# TRAFFIC IMPACT ASSESSMENT (TIA)

**Proposed Waste Management facility  
2-4 Hale Street, Botany**

Reference: 23.464r01v13  
Date: March 2025

## 2. RESPONSE TO REQUEST FOR INFORMATION

Drawing Title  
**DRIVEWAY SECTION**

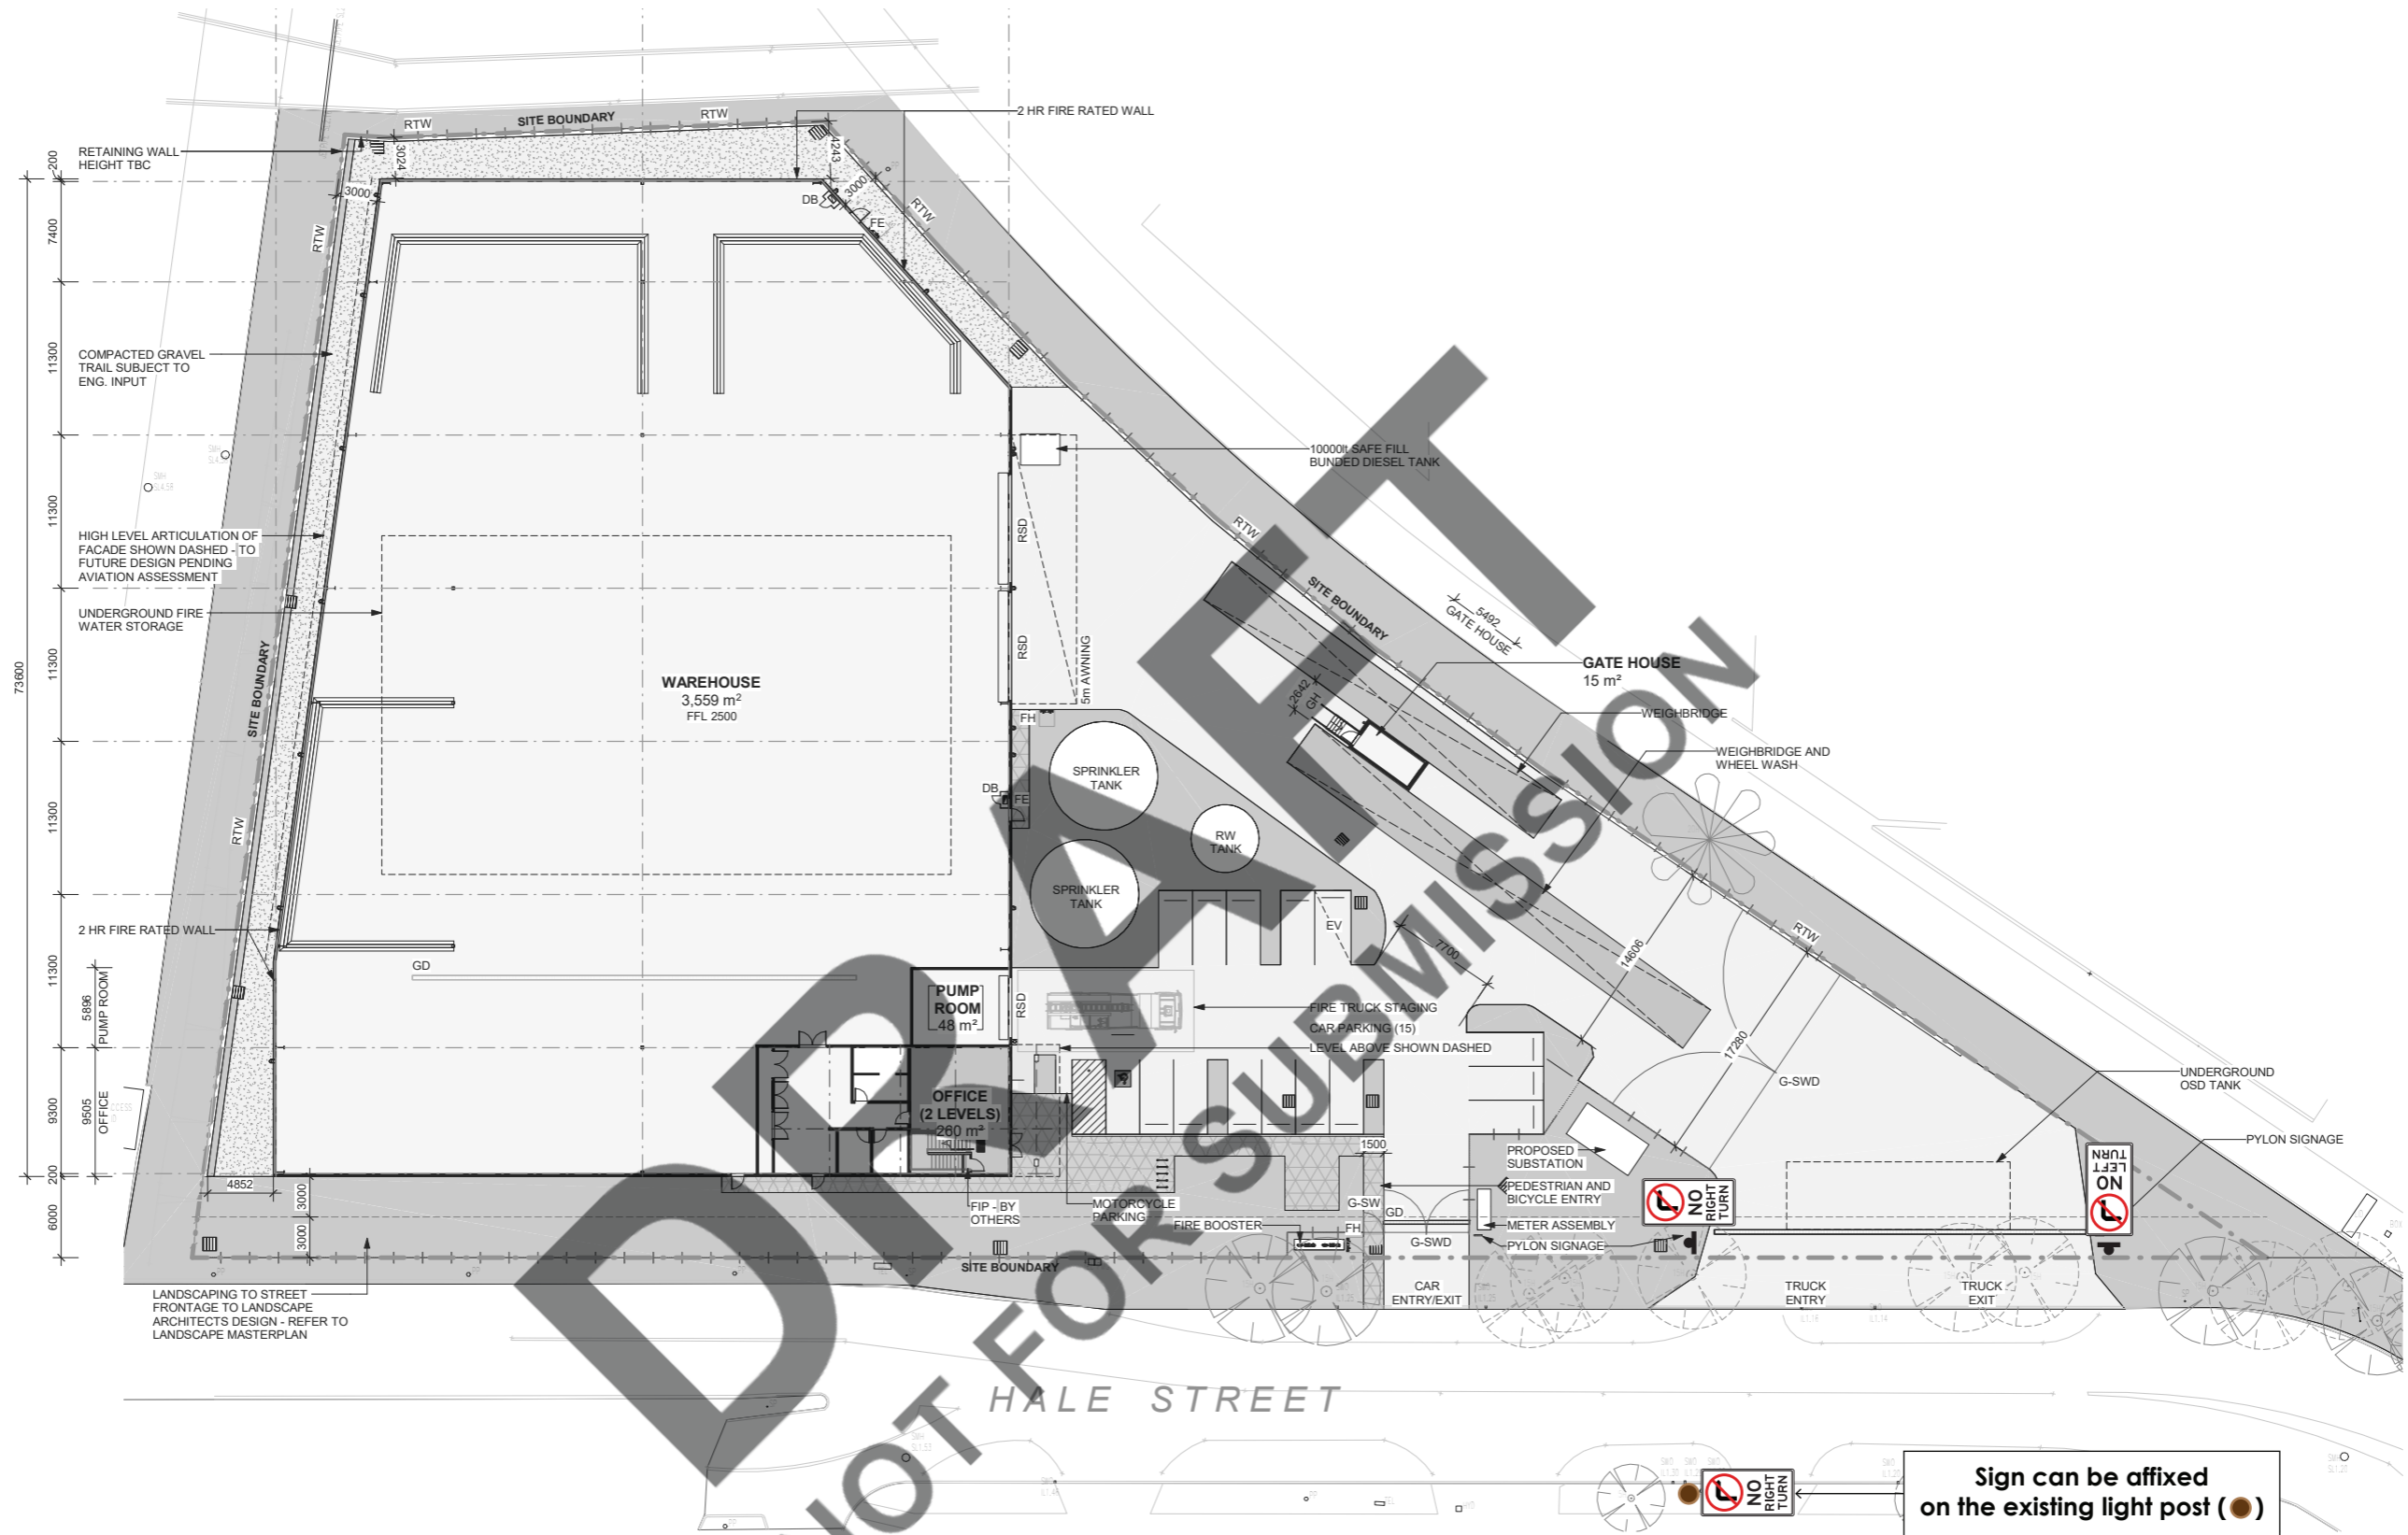
<p>A longitudinal driveway profile is to be submitted for each driveway. The profiles shall start in the centre of the road and be along the critical edge (worst case) of the driveway. Gradients and transitions shall be in accordance with AS2890.1:2004 &amp; AS2890.2:2018. The profile shall include all relevant levels, grades (%), headroom clearances and lengths. The existing boundary levels shall be clearly shown on the profile. Any change to the existing boundary levels requires approval from Bayside Council.</p>	<ul style="list-style-type: none"> <li>A longitudinal driveway profile has been prepared demonstrating compliance with AS 2890.1 (2004) and AS 2890.2 (2018) and has been submitted as part of the updated SSD package.</li> </ul>
<p>Internal driveway gradients shall be clearly shown on the plans complying with AS2890.1:2004 and AS2890.2:2018.</p>	<ul style="list-style-type: none"> <li>Internal gradients have been clearly shown on the plans demonstrating compliance with AS 2890.1 (2004) and AS 2890.2 (2018) and has been submitted as part of the updated SSD package.</li> </ul>
